10-14 Gordon Street, Blacktown

This letter is prepared on behalf of our client, Gordon Developers Pty Ltd, to matters raised during the council meeting held on 10 April 2017, in regards to the proposed residential flat building development at 10-14 Gordon Street, Blacktown, also can be legally described as Lot B, C & D DP 371472.

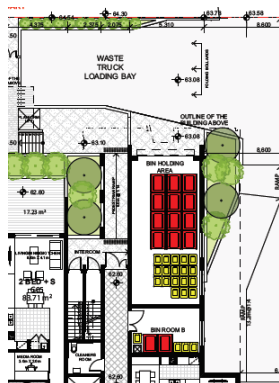
- 3. Building Height

The revised development has considerably reduced the height exceedance. Structures breached the 20m height limit include the lift overruns, the fire stairs and part of the communal open space. All residential components are now below the height limit. The height exceedance does not contribute to the Gross Floor Area and is considered as a reasonable outcome addressing council's concern in the council meeting.
